UNITED STATES PATENT AND TRADEMARK OFFICE

| APPLICATION NO. | FILING DATE | FIRST NAMED INVENTOR | ATTORNEY DOCKET NO. | CONFIRMATION NO. |
|-----------------|-------------|----------------------|---------------------|------------------|
| 09/764,936 | 01/18/2001 | Roland Eberlein | 4965-000114 | 9936 |

Office Action Summary

DETAILED ACTION

Appendix

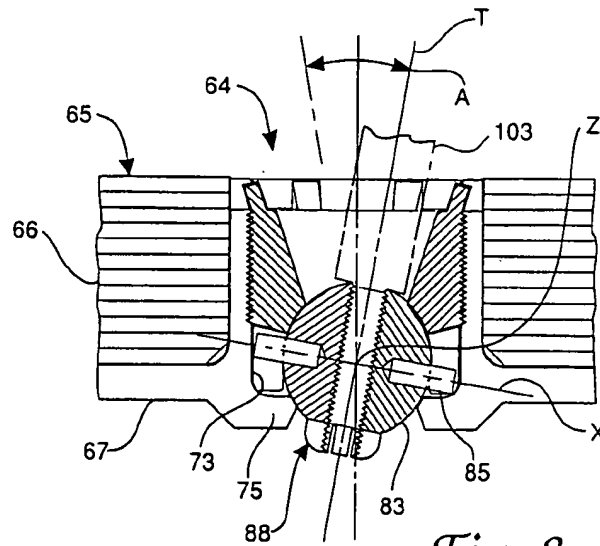
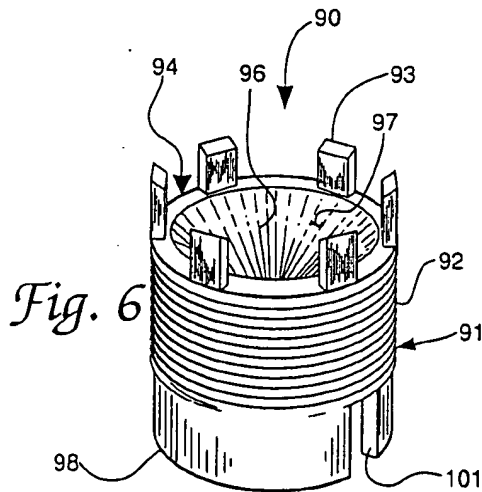
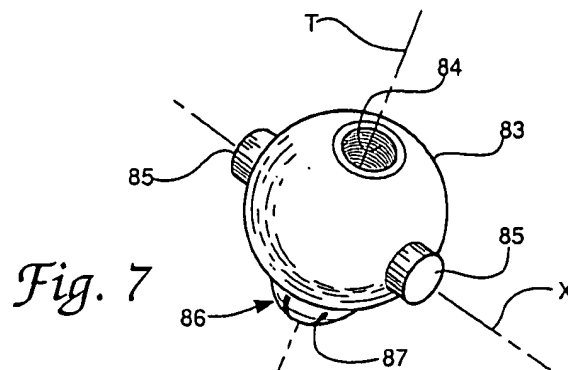
- a. Stoffer et al. fail to teach or suggest a hole having an inner surface that is formed about spherically curved. However, Stoffer et al. do have a hole having an inner surface that is formed about spherically curved. An Appendix has been provided showing the spherically curved portion in green.

- d. Stoffer et al. fail to teach or suggest a bushing further having a seat for at least partially receiving at least a partial surface of the head of the screw. However, again given the bushing is element 67, not element (83), there is a seat, shown in red in an Appendix that has been provided.

* general area of the seat for receiving the head of the screw

● hole having an inner surface that is formed about spherically curved.
